# UNITED STATES PATENT AND TRADEMARK OFFICE

APPLICATION NO.	FILING DATE	FIRST NAMED INVENTOR	ATTORNEY DOCKET NO.	CONFIRMATION NO.
09/773,241	01/31/2001	John C. Molander	8409	6142

# Office Action Summary

col. 10, lines 3 – 37 and in figure 1 (as shown below) and in figure 6.

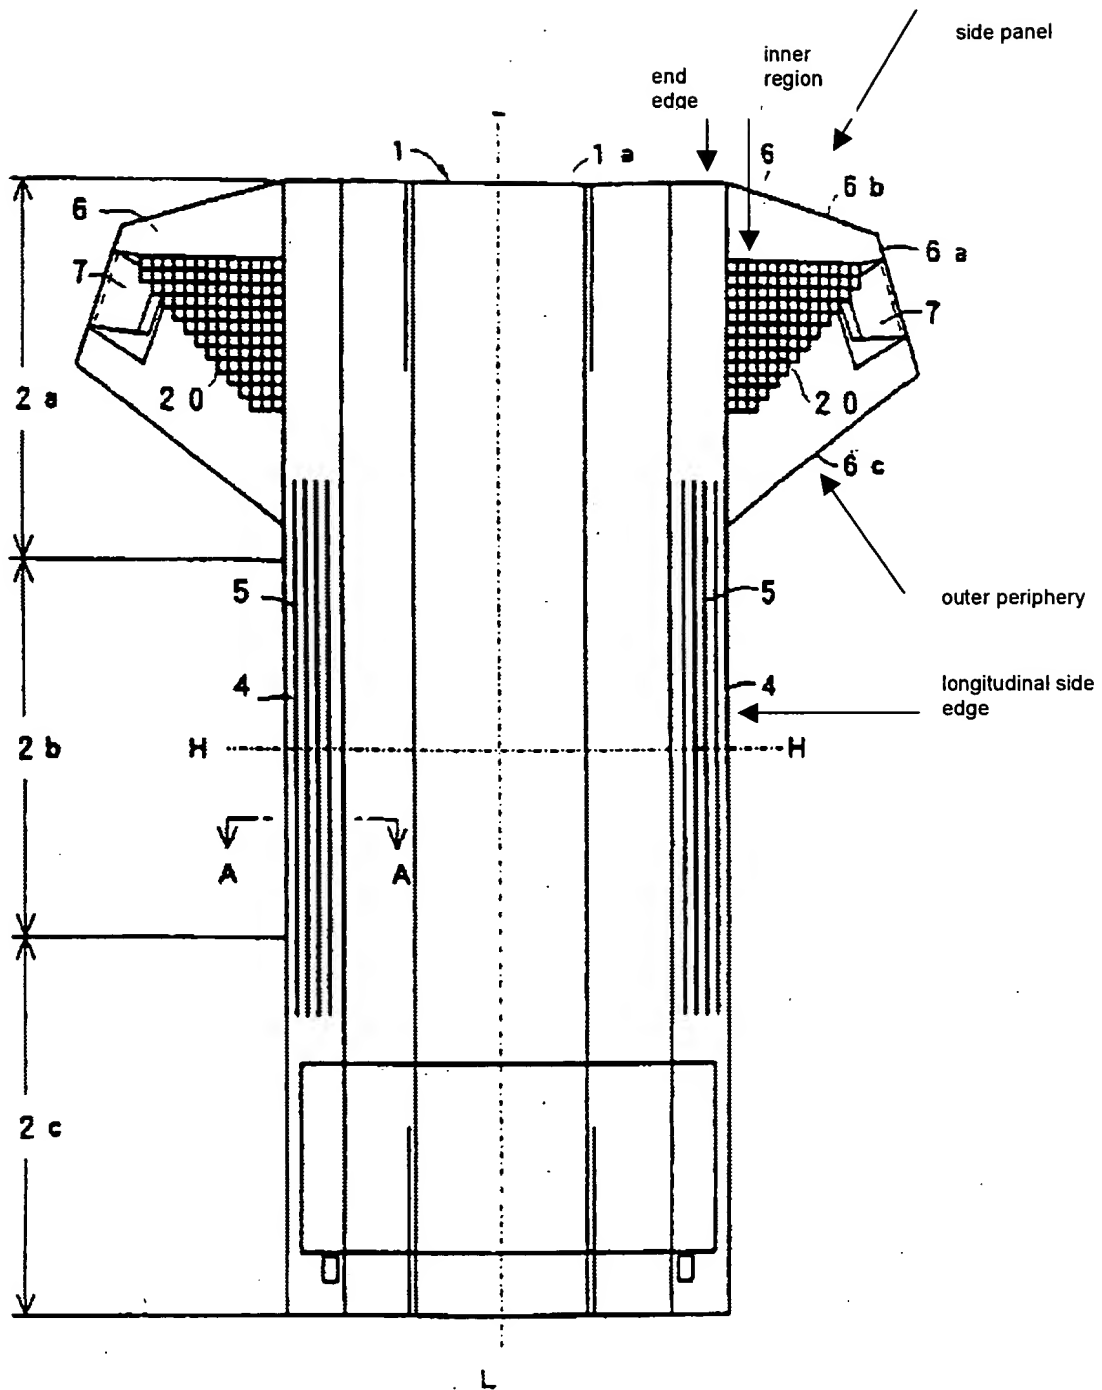
As to claim 1, Heki et al. (hereinafter “Heki”) discloses a disposable article comprising a containment assembly (Figure 1) having a first longitudinal edge and a second longitudinal edge opposed thereof, a first end edge and a second end edge opposed thereto, the first and second longitudinal edges being configured to contact the legs of the wearer, and the first and the second end edges being structured and configured to contact the waist of the wearer; and at least one side panel (6) carried by the containment assembly (Figure 1), and extending outwardly from the first longitudinal edge of the containment assembly adjacent the first end edge of the containment assembly, the at least one side panel including an outer periphery and an inner region having at least one discontinuity (20) limited to the interior region for dividing a tensile force applied to the at least one side panel into a waist-directing force and a leg-directing force wherein the at least one discontinuity is neither directly or indirectly connected (inasmuch as disclosed by applicant) to the outer periphery as set forth in

As to claim 2, Heki discloses a disposable article wherein at least one side panel further includes a waist region (top of article as shown in figure 1) and leg region (area generally designated by reference characters "4" and "5" in figure 1) separated thereof by the at least one discontinuity (20), the waist region is configured to transmit the waist-directing form, and the leg region is configured to transmit the leg-directing force as set forth in col. 12, line 49 to col. 13, line 5.
